Subject: Addenda to APPLICATION FOR REVISION OF MINE PERMIT #C1002RE FROM STANDBY TO ACTIVE STATUS and MODIFICATION OF GROUND WATER DISCHARGE PERMIT DP-61 MT. TAYLOR MINE, SAN MATEO, NEW MEXICO, Rev.1, for Addition of Molybdenum/ Selenium (MoSe) Treatment Building

Addendum to the Application for Revision of Mine Permit #C1002RE from Standby to Active Status, Mt. Taylor Mine; July 9, 2015

Addendum to the Closeout/ Closure Plan (CCP) for Revision of Mine Permit #C1002RE from Standby to Active Status, Mt. Taylor Mine; July 9, 2015

Re: RE: Mt Taylor Mine/Discharge Permit 61 - New Mexico Environment Department comments on "Operations and maintenance manual; Mine Water Treatment Unit (MTWU) - uranium IX and molybdenum/selenium treatment facility [text and plans] (LNV, March 19, 2015)

7 MOLYBDENUM AND SELENIUM PROCESS FLOW DIAGRAM
NOT TO SCALE

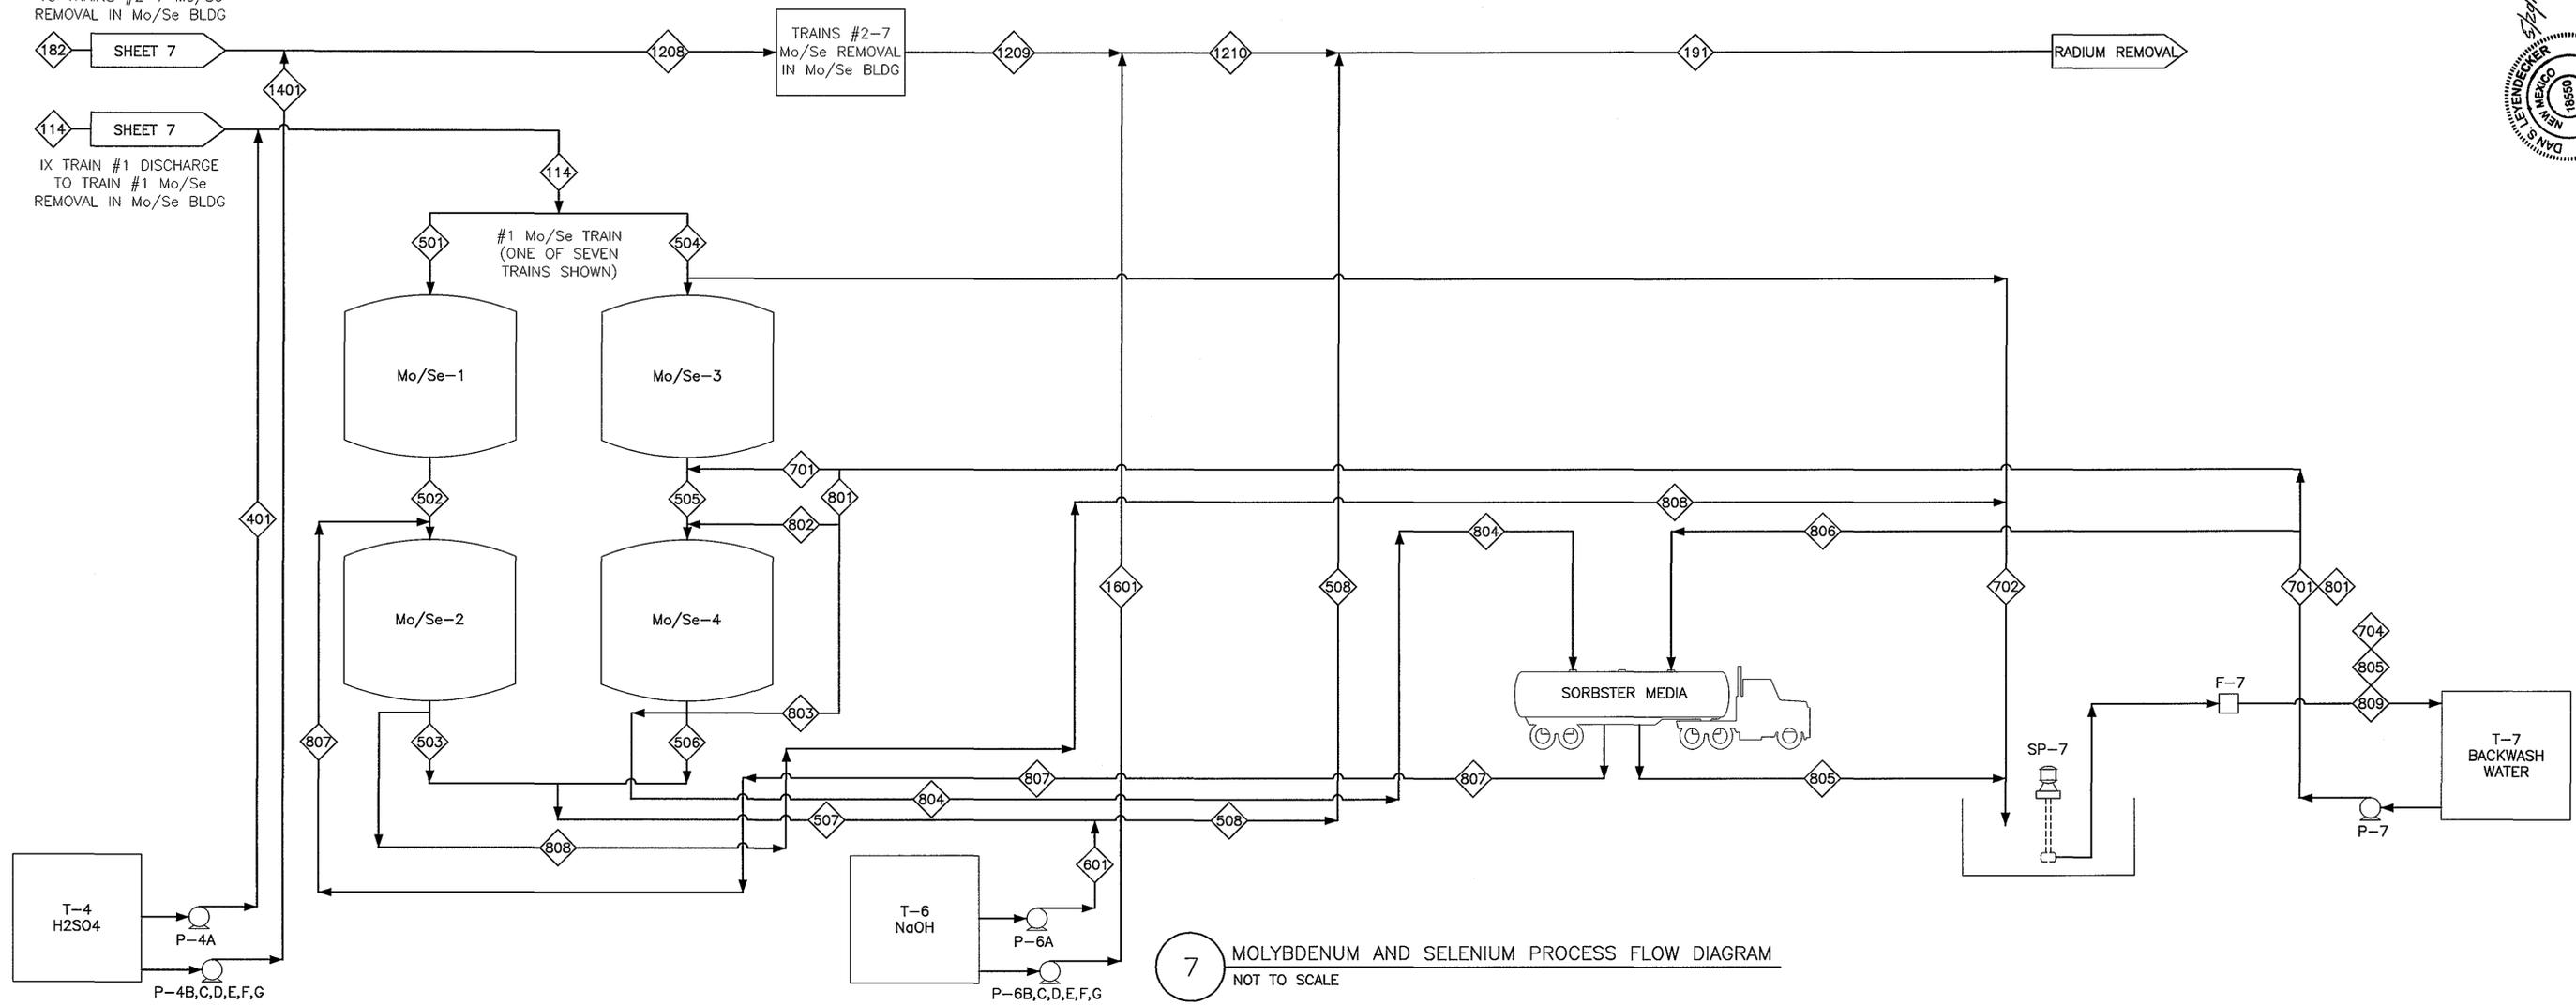
Comment No.	Page	Text or Reference	NMED Comment	RGRC Response
13		Sheet 7	This sheet does not show provision for outflow from T-1 (i.e., overflow tank). However Sheet 9 shows overflow return to the mine water wet well. Please explain.	Sheet 7 has been revised to show overflow return to the mine water wet well. Sheet 7 is the Uranium process flow diagram and shows the flow rate through the ion exchange vessels and the IX resin transfer system. T-1 is an emergency overflow tank (50,000 gallons) which returns any overflow back to the mine water wet well. Sheet 9 shows the process flow diagram for the mine water wet well which shows overflow from both tank T-1 and overflows from the IX resin transfer water tanks T-2A and T-2B

MT. TAYLOR URANIUM MINE/RIO GRANDE RESOURCES CORP., NEW MEXICO
 URANIUM ION EXCHANGE & MOLYBDENUM AND SELENIUM ADSORPTION FACILITY
 URANIUM P&ID—MINE WATER WET WELL

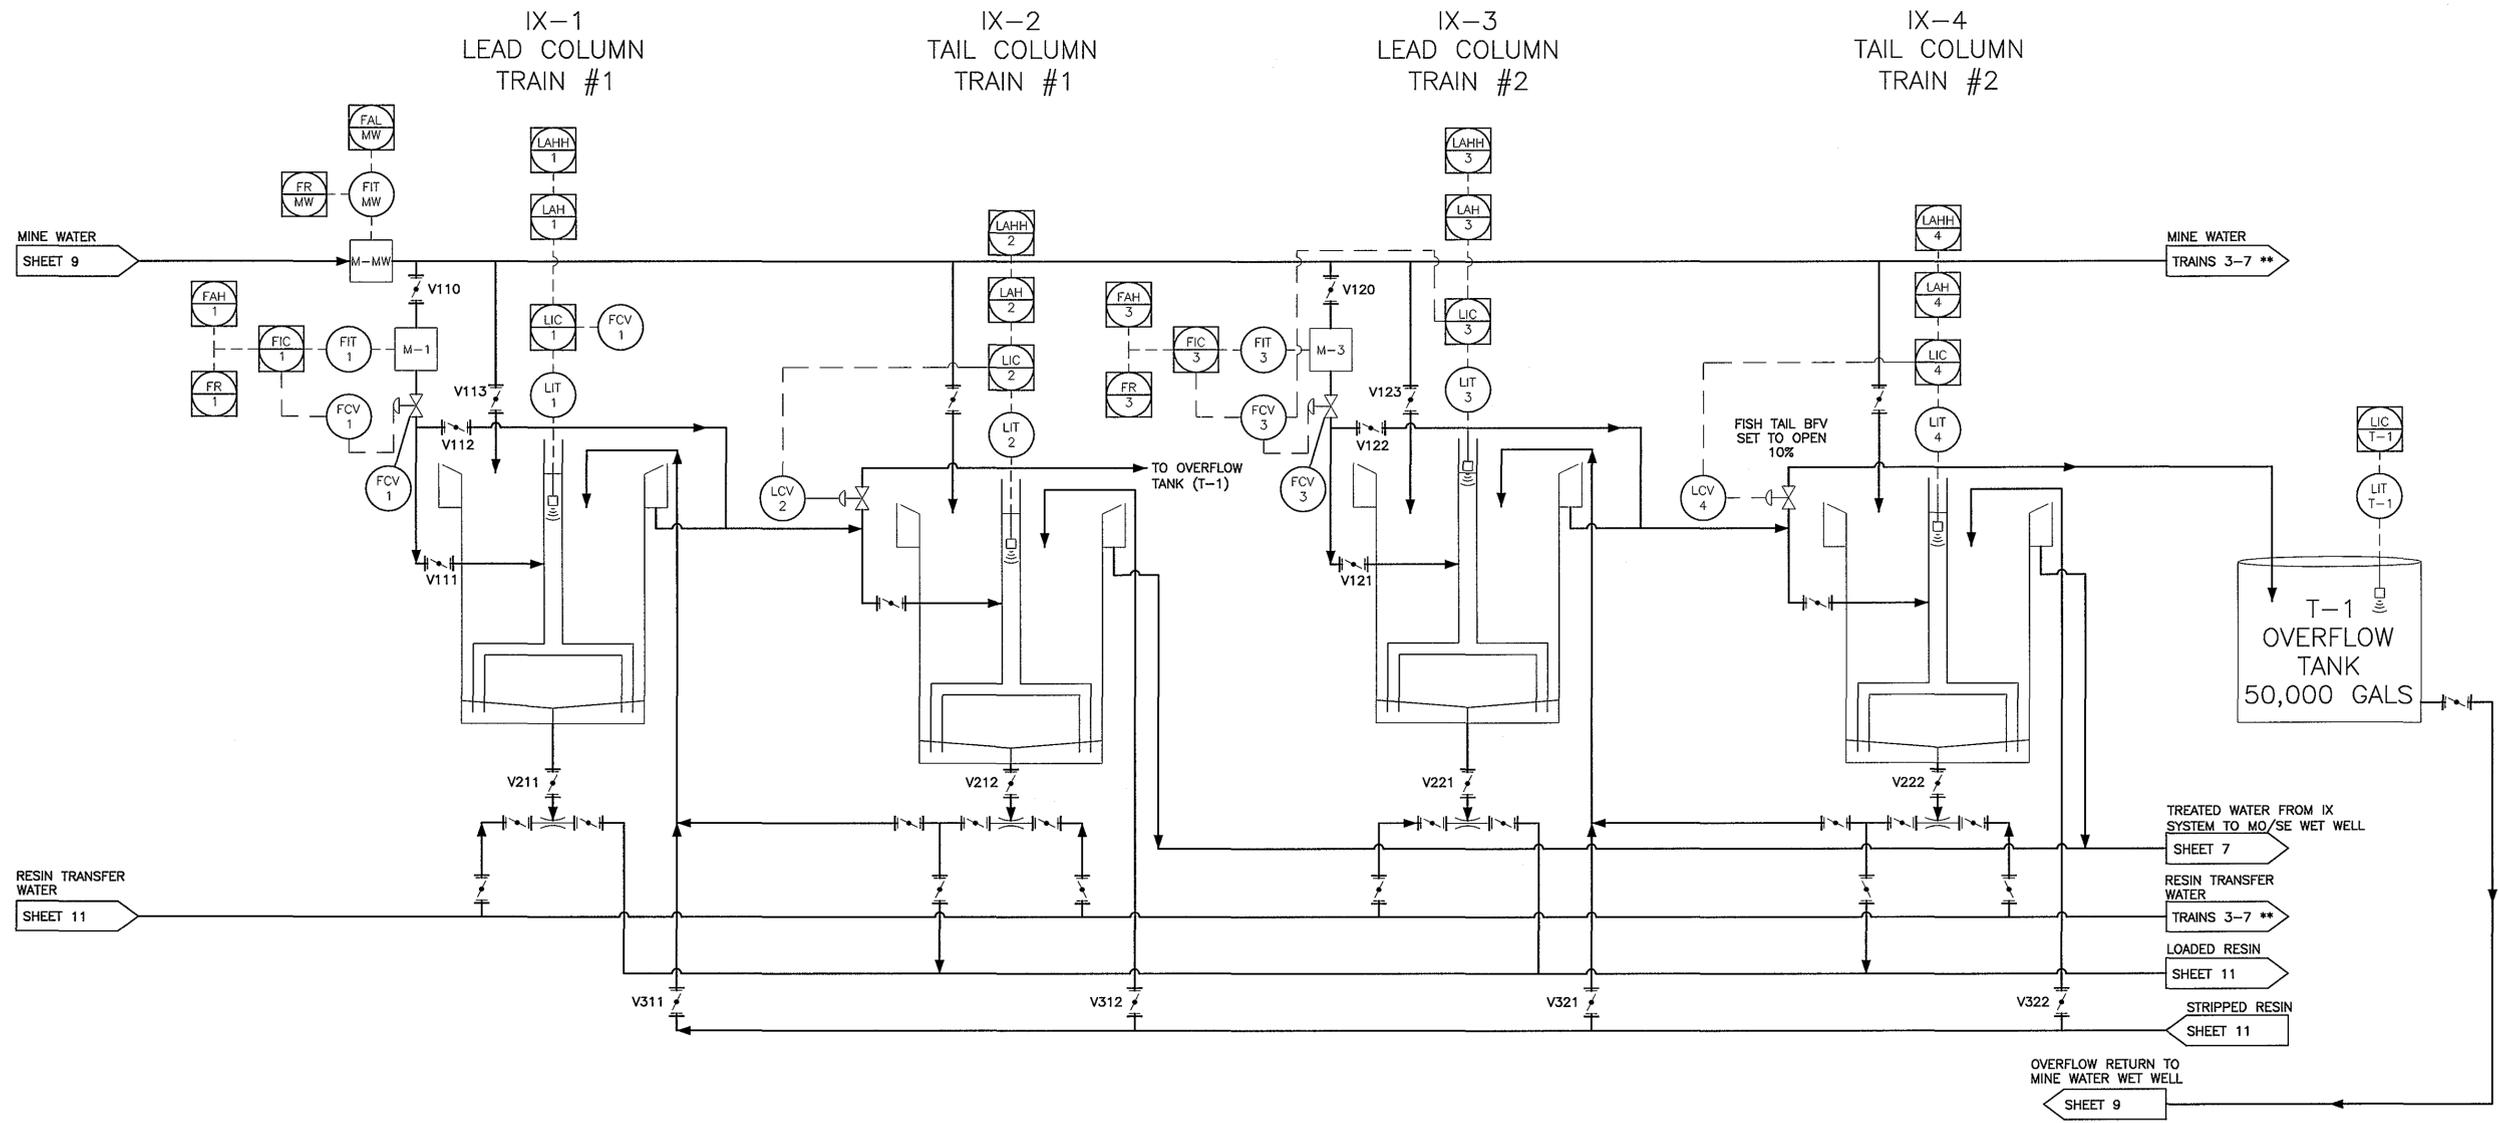
14.1		Sheet 9	Please explain the functionality of LAHH/MW with respect to precluding overflow from the mine water wet well.	The LAL will slow the IX feed pumps down to prevent depleting all the water in the wet well. The LAH will speed the pumps up to increase the IX feed rate and raise an alarm to notify the operator of a throughput issue. If the wet well level continues to rise, a LAHH would alert the operator that the IX system cannot handle the feed rate at which water is coming into the wet well and an overflow would occur. The overflow would bypass the uranium treatment system at rate equal to the difference between the well influx and the IX feed rate. Once the LAH is reach, the operator will be trained to monitor the wet well level and if the level continues to rise, he/she will have the option to reduce the incoming flow rate to the wet well so as to prevent an overflow from occurring.

14.2		Sheet 9	This sheet shows overflow from T-2A/T-2B comes from these components appearing on Sheet 10; however these components are not shown on this sheet, but rather are shown on Sheet 7. Please explain.	Sheet numbers have been revised.

14.3		Sheet 9	This sheet shows overflow return comes from a component appearing on Sheet 9 into the mine water wet well; however the overflow tank (i.e., T-1) is shown on Sheet 7. Please explain.	Sheet numbers have been revised.

14.4		Sheet 9	This sheet shows outflow from the mine water wet well is routed to the IX system appearing on Sheet 9; however inflow to the IX Plant is shown on Sheet 7. Please explain.	Sheet numbers have been revised.
15		Sheet 10	This sheet shows overflow return from T-1 is routed to Sheet 8; however overflow return to the mine water wet well is shown on Sheet 9. Please explain.	Sheet numbers have been revised.

8 MOLYBDENUM AND SELENIUM BUILDING LAYOUT AND CONTAINMENT PLAN
SCALE: 1"=10' (HALF SIZE SHEETS)
SCALE: 1"=5' (FULL SIZE SHEETS)

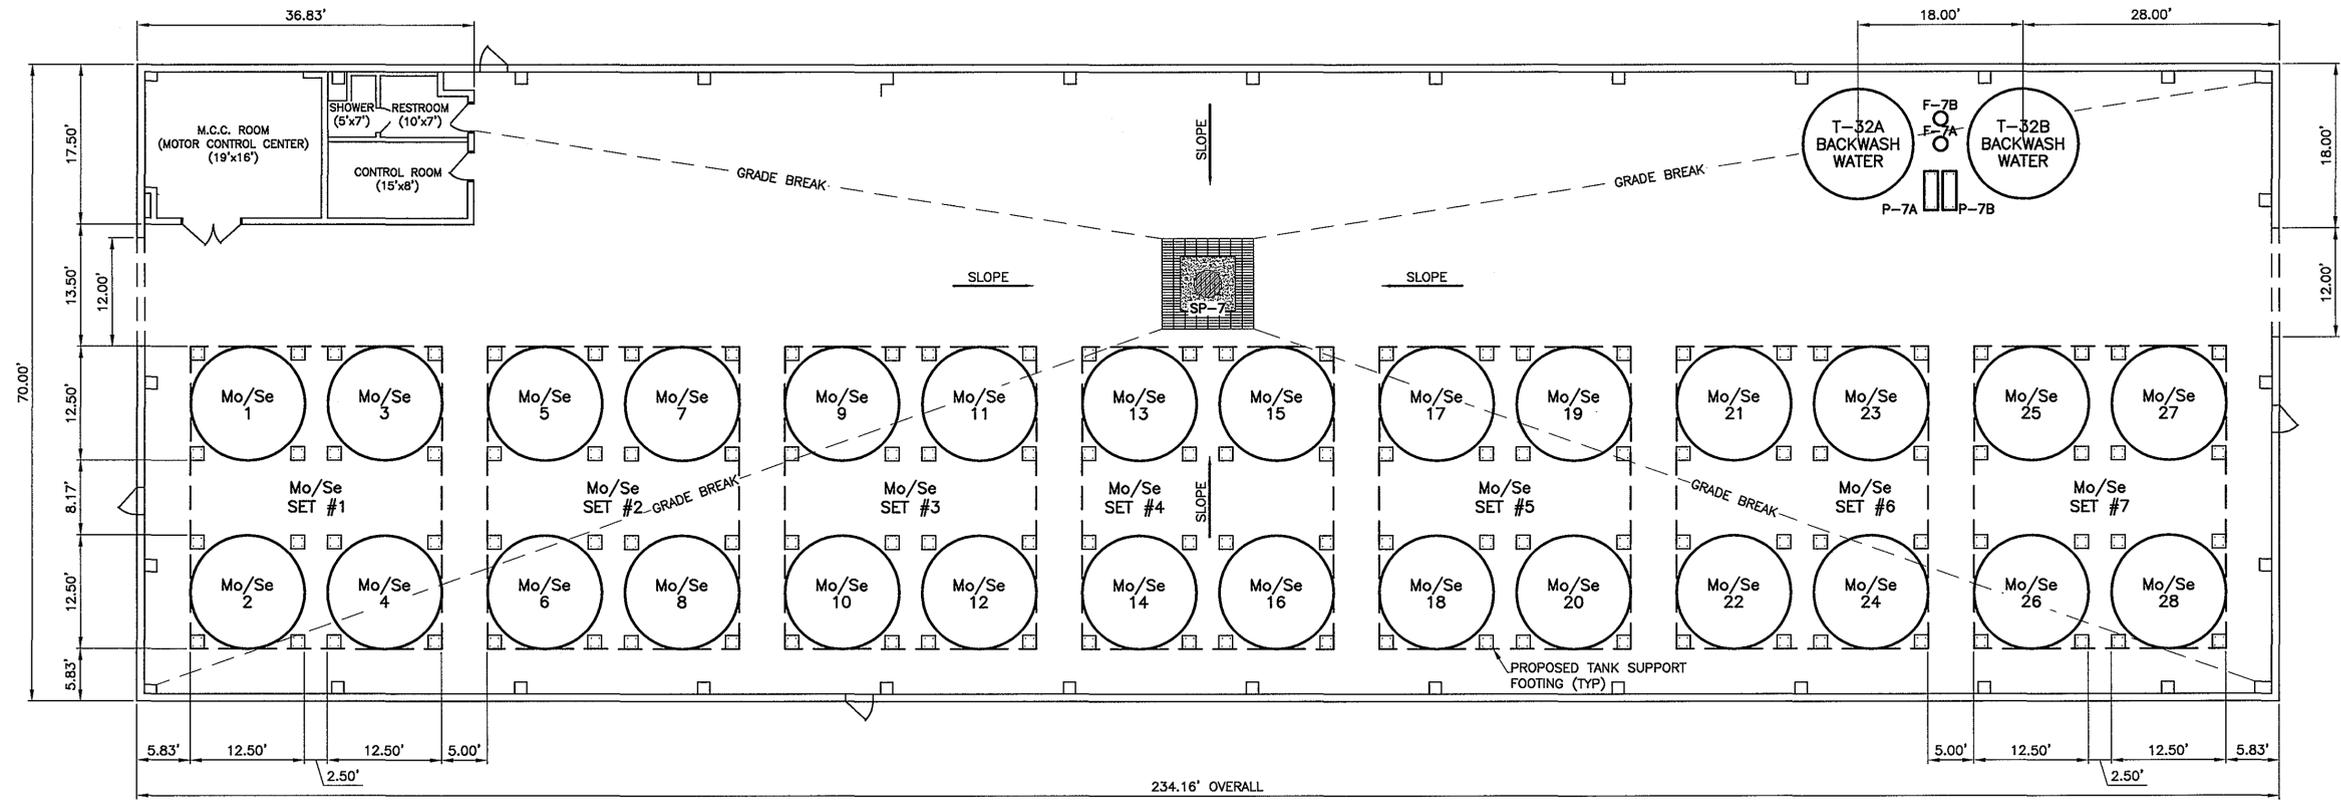
Comment No.	Page	Text or Reference	NMED Comment	RGRC Response
1			Please submit a figure and text pertaining to containment for the molybdenum and selenium treatment plant building	Sheet 13 has been modified to show floor slope and curb for containment
2	1	Phase 2 - Mine operation... - Mo 0.530 ppm - Se 0.090 ppm	NMED's review of quarterly monitoring data that was submitted during the final 3 full years of the prior mine operational period (attached) indicates the following range of concentrations (in ppm) in discharged mine water effluent: - Mo: 0.8525 (1987) to 1.317 (1989) - Se: 0.033 (1989) to 0.136 (1988)	The referenced data was taken during the years of mining when the dewatering flow rate was less than 5,000 gpm. The proposed system is designed to handle a dewatering flow rate of 10,000 gpm in which the Mo/Se concentrations will be lower than design concentrations. As bench testing occurs and actual dewatering data is obtained, the Mo/Se system will be modified to meet incoming concentrations. The design flow rate through each train is 6 gpm/sq. ft cross sectional area of media. Once this flow rate is reduced, the loading efficiency will increase and the tail column concentrations will drop for both Mo and Se.

PROJECT TITLE: MT. TAYLOR MINE MINE REACTIVATION PLAN	REV 2
SHEET TITLE: MINE WATER TREATMENT UNIT (MWTU) UPGRADES

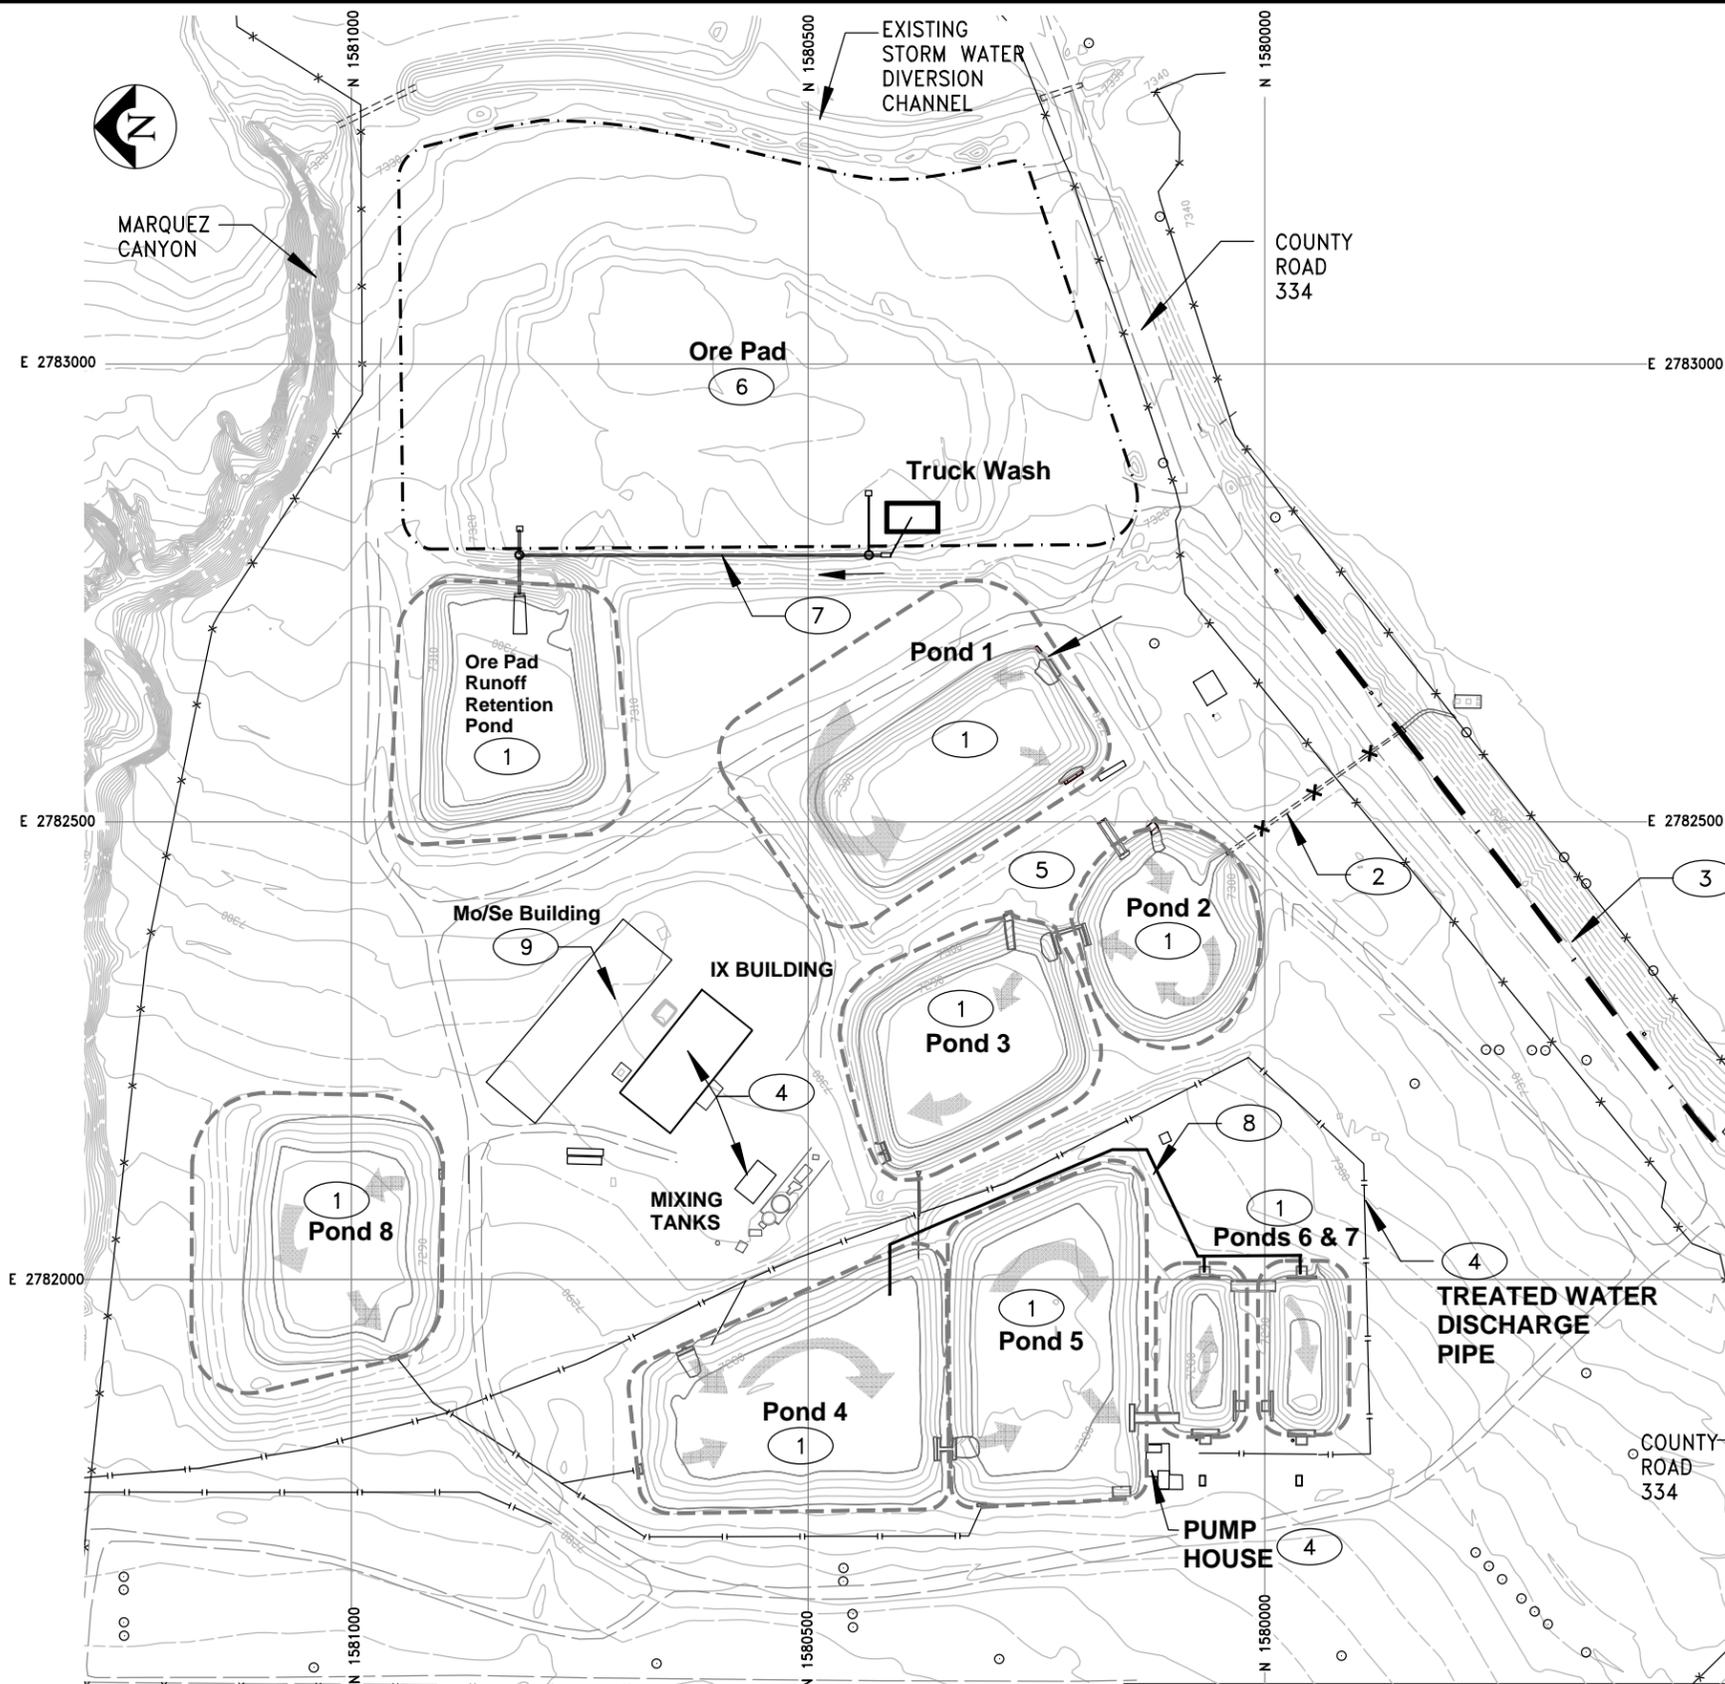
- 8 ADDITIONAL BYPASS PIPING AROUND POND 5
- 9 NEW MO/SE ADSORPTION BUILDING (PLANS BY OTHERS)
